Product Change Notification (PCN)

PCN Number	500735	Date Issued	March 14, 2017
Reason for Change	Manufacturing Process Change Molex and Suppliers		
Change Type Description	This letter is to inform you that the manufacturing process for the part(s) identified in this notice is changing. No changes will be made to the product as a result of this process change.		
Assessment of Change	Product will be fully qualified before it is shipped. Qualification reports are available upon request.		
Internal Molex Qualification Date	June 30, 2016		
Sample Availability Date (Changed Part)	June 30, 2016		
Planned Implementation Date	September 16, 2016		
Method of Identifying Change	Date code

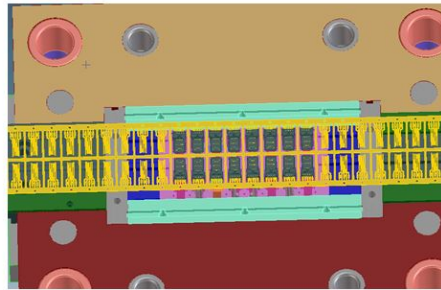
Before Change

1) Eight cavities each
 mold & manual insertion mold

After Change

1) Sixteen cavities each mold & auto insertion mold
